# CITY PLAN COMMISSION STAFF REPORT

**Fashionbilt**

CD-CPC-2021-00174

UR Rezoning + Development Plan

CO.10

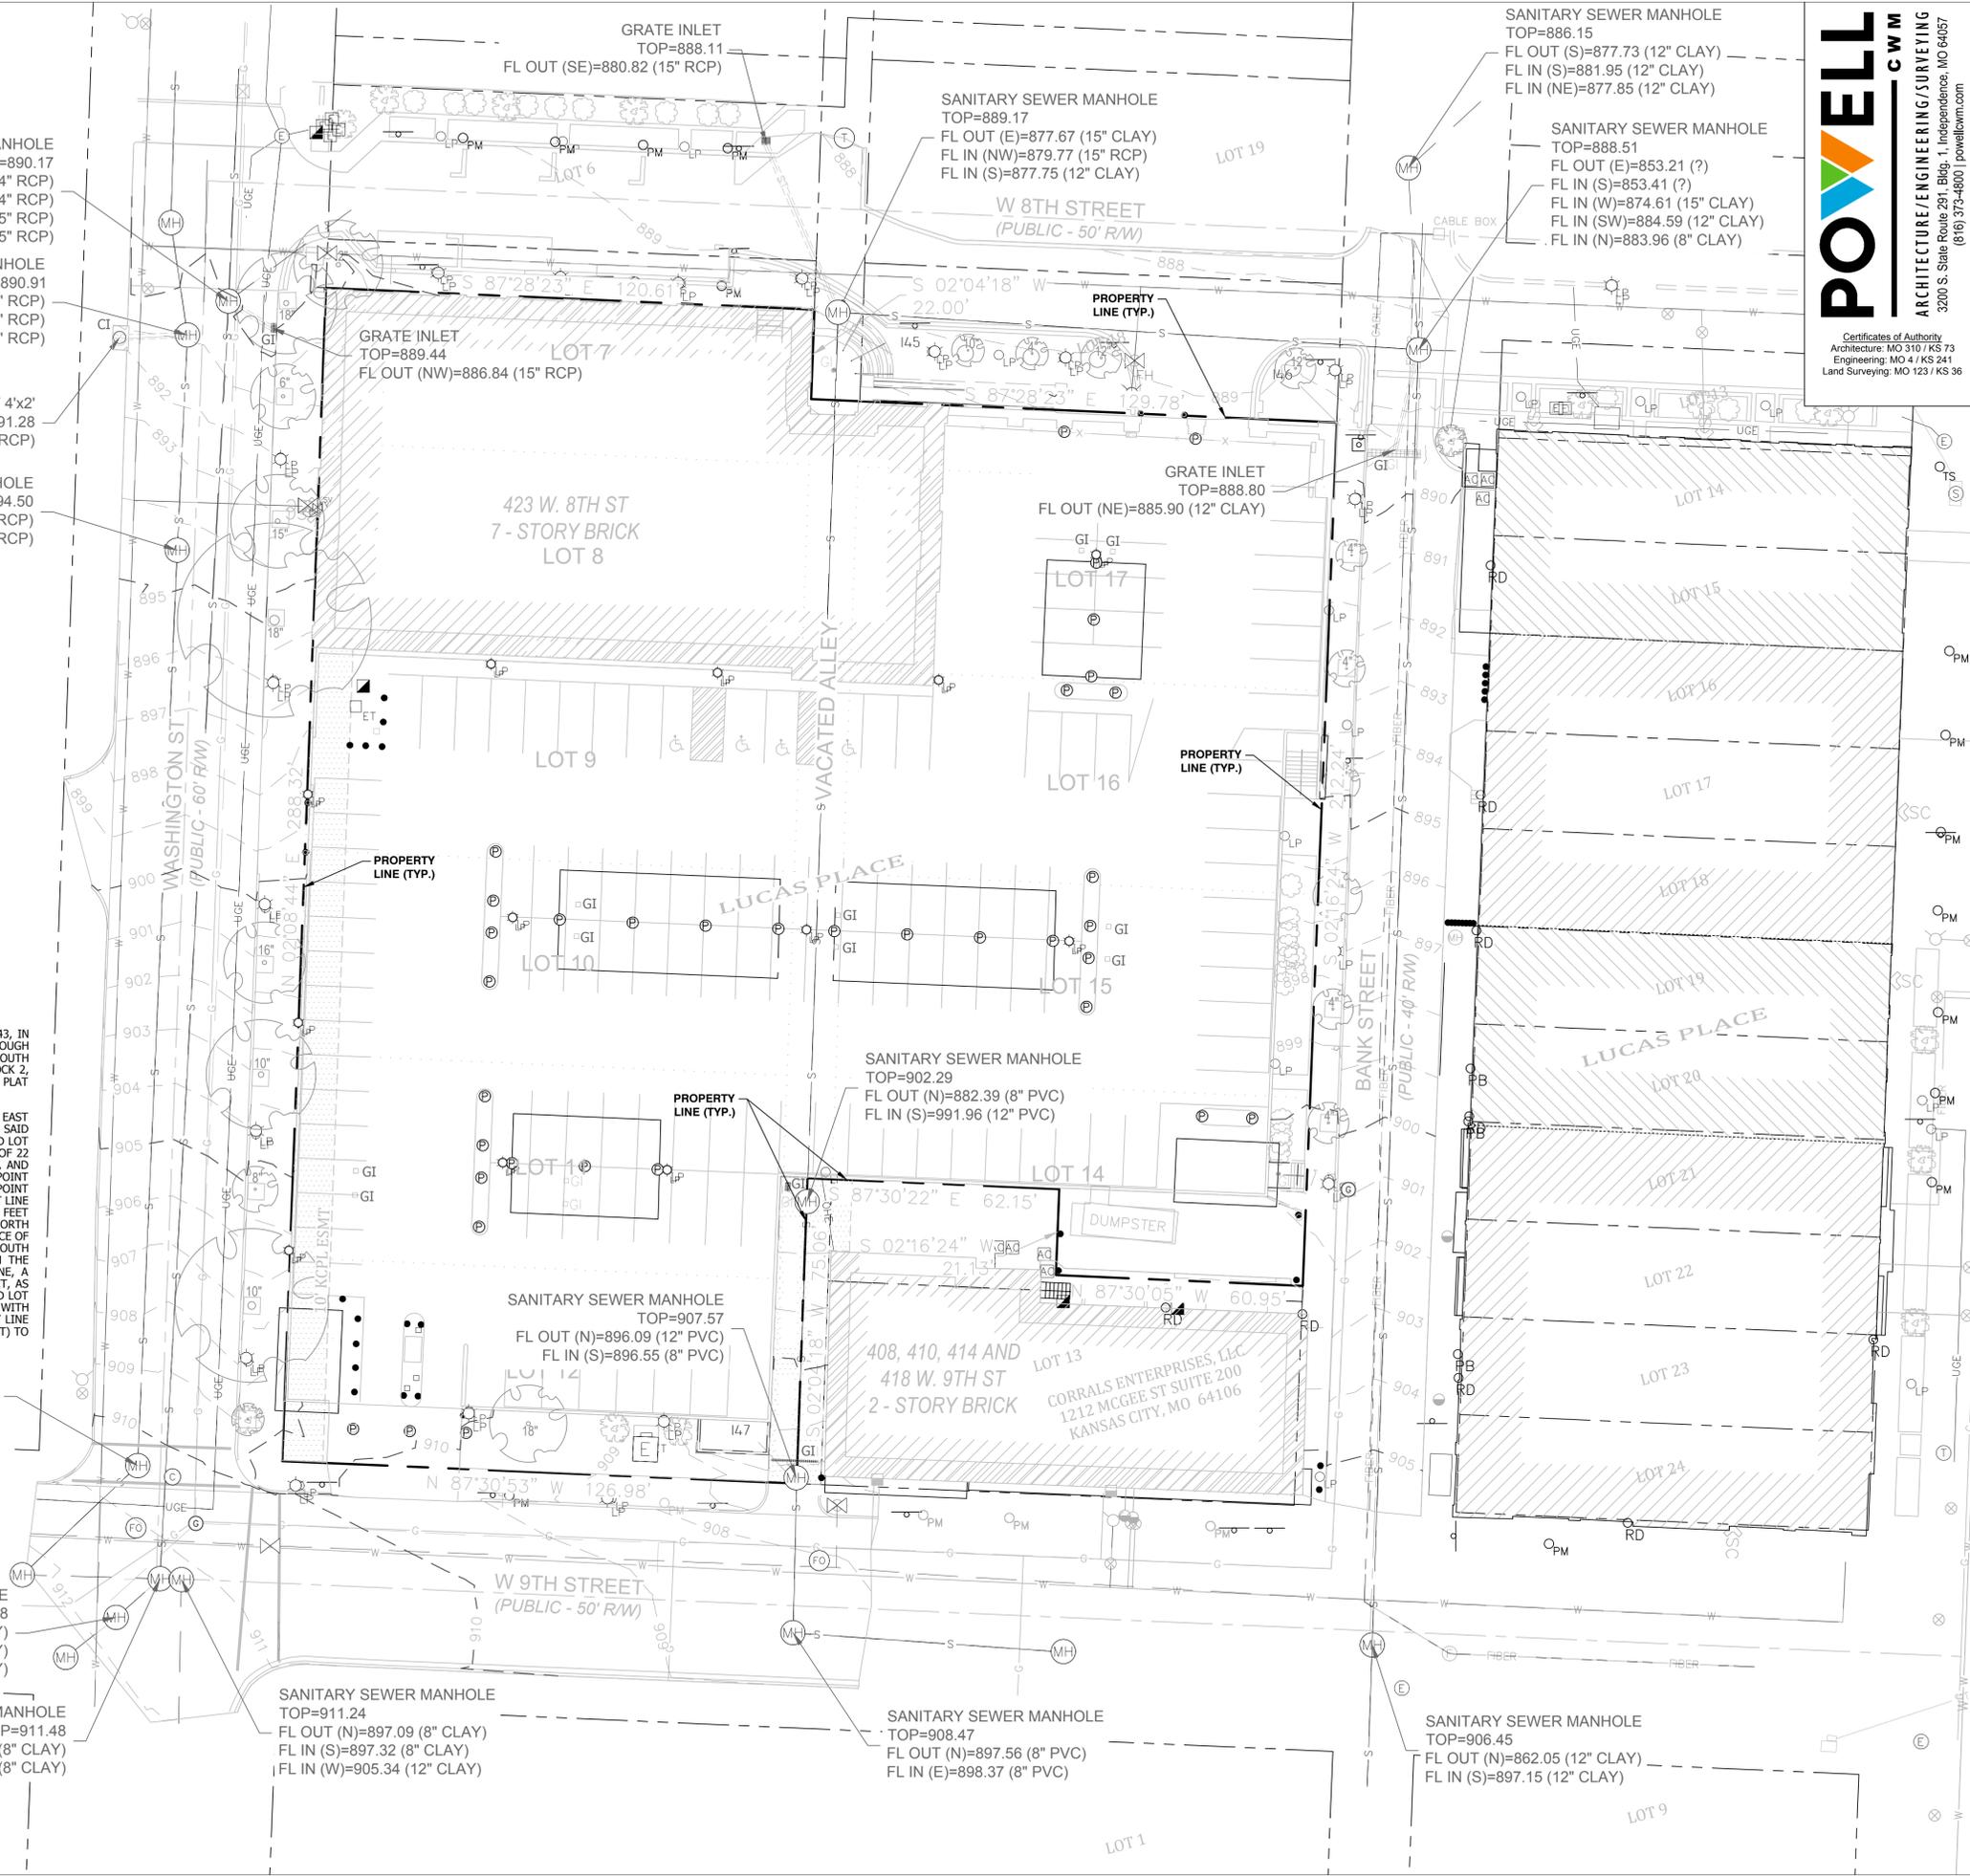
34. The developer must either move the proposed driveway or submit Fire Hydrant Relocation plans to move Fire Hydrant H-24 located along 8th Street between Washington Street and Broadway Boulevard on the south side of 8th street. The fire hydrant plans shall be prepared by a registered professional Engineer in Missouri. The plans shall be submitted to the water main extension office for review, acceptance and contracts per the KC Water Rules and Regulations for Water main extensions and Relocations.  
(<https://www.kcwater.us/wp-content/uploads/2019/04/2018-Rules-and-Regulations-for-Water-Main-Extensions.pdf>)

Note: The existing Fire Hydrant appears closer than 2' to the proposed driveway.

Note: The utility sheet shows Install per KCMO STANDARDS:  
Please change because it is an 8" Water main on 8thStreet (9/20/2021)

**01 BASEMENT FLOOR PLAN**  
1/8" = 1'-0"

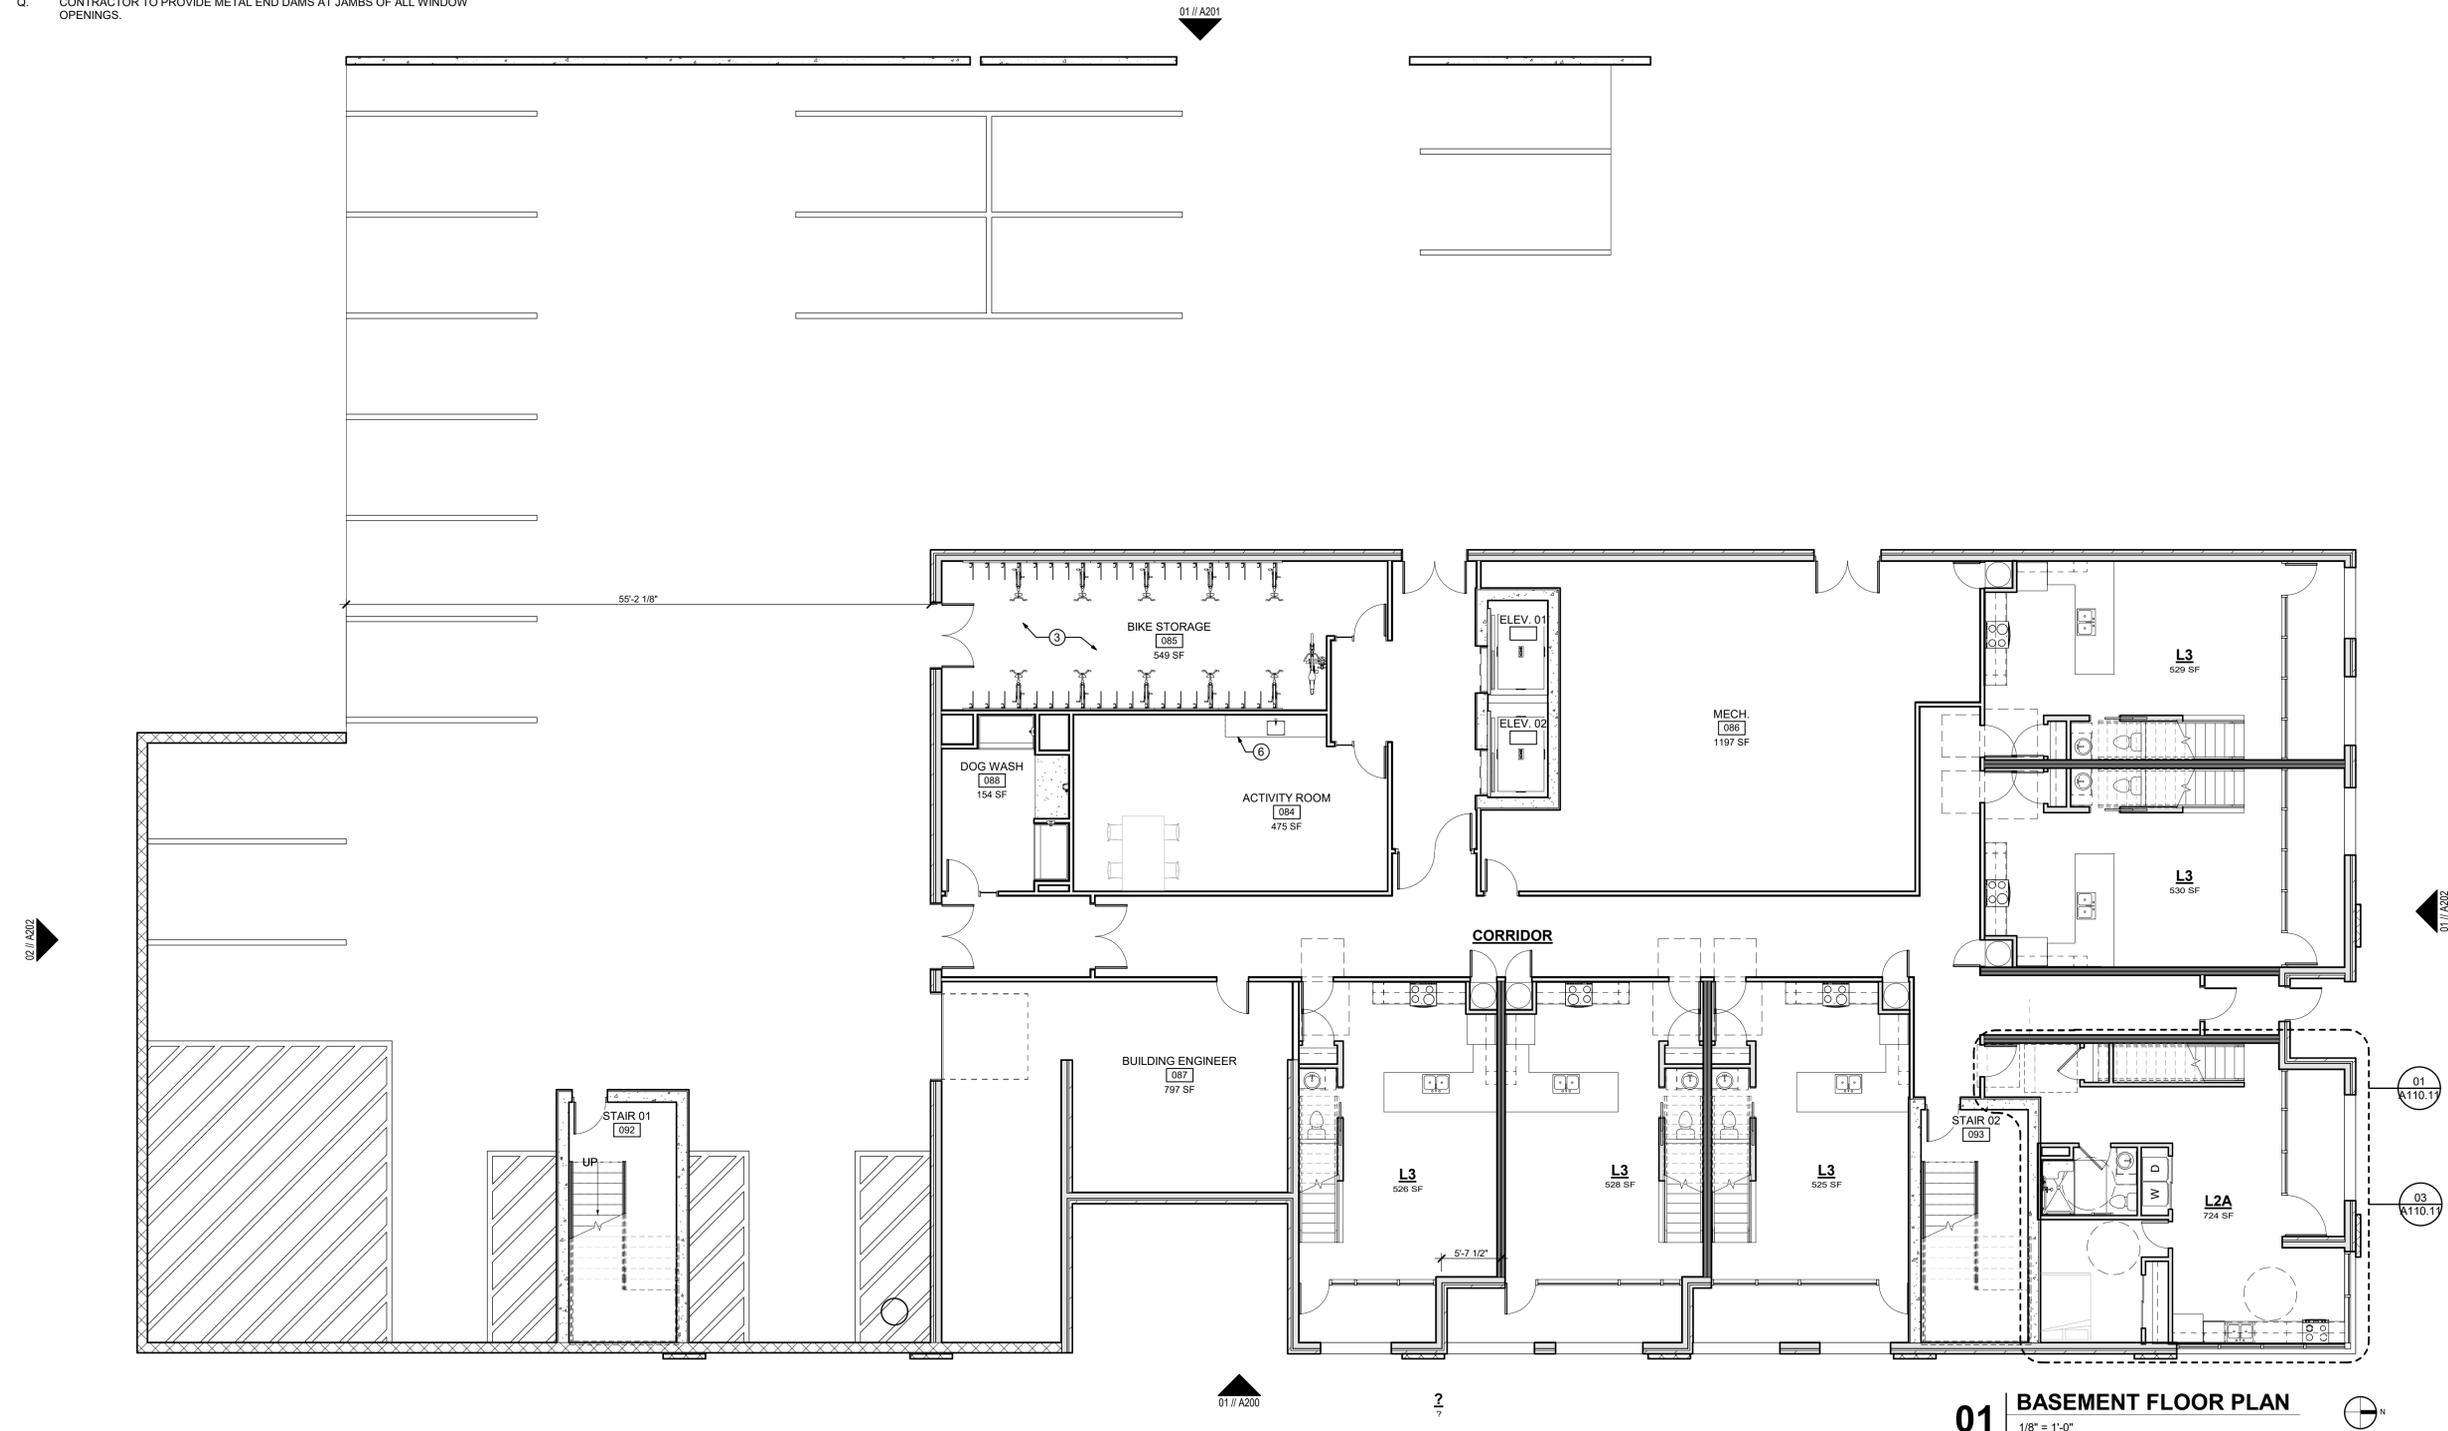
1. Per 88-130-06, in all D districts, or with a project with an underlying D district zoning, the ground floor of new construction for lots with 50 feet of frontage or more must contain at least 20% of square feet of commercial floor space. Other design possibilities include re-orienting the layout so main entrance faces 8th Street, adding personal entrances to units is off 8th St, or request deviation from Zoning and Development code.

12/21/2021. Applicant indicated in the response letter that garden entry apartments with storefront glazing will be designed along the 8th street frontage for the new building. City staff is still a little confused about what you're proposing. It appears that the first level of the building is at the same (or nearly so) grade as 8th St and elevated above ground level. The access and relationship to the basement units is unclear.

4. In conjunction with correction 3, if the basement level is at ground level and that is below-grade of 8th St, show us how those units will be provided with adequate light and air (particularly since you are showing doors and windows onto those units). It is difficult for City staff to imagine how these units will be able to have windows/doors and thus adequate light and air as the current drawings depict. Revise Plans and Resubmit (12/23/2021)

Our goal is to give residents, who have units along 8th street, a method of accessing their units directly from 8th St. Revise Plans and Resubmit (12/14/2021)

EXTERIOR ELEVATIONS

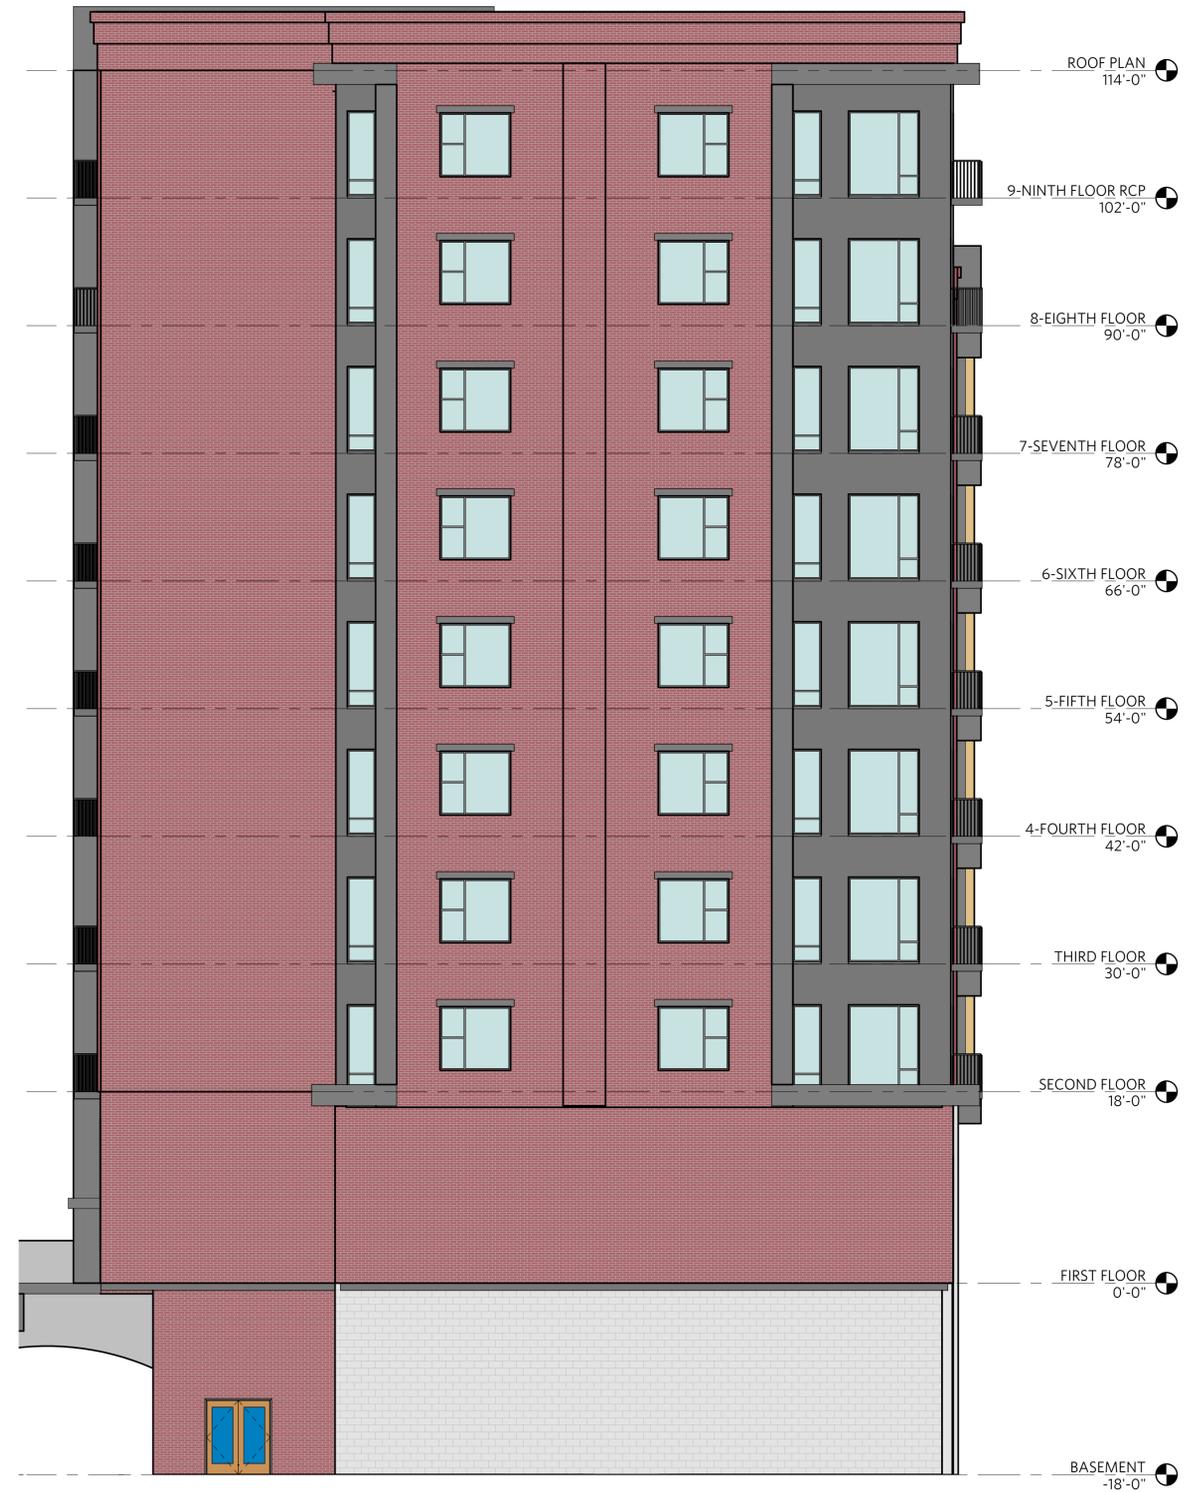
2. Provide color north, south, east, and west elevations labeling materials and pedestrian entrances.

12/21/2021. The correction above needs to occur for both buildings on the subject site, proposed development and historic rehabilitation.

Materials are still not labeled for elevations provided. Revise Plans and Resubmit (12/14/2021)

6. Provide additional fenestration or architectural articulation up and down the west portion of the south façade (that appears to be on a separate plane from remainder of south façade). Revise Plans and Resubmit (12/23/2021)
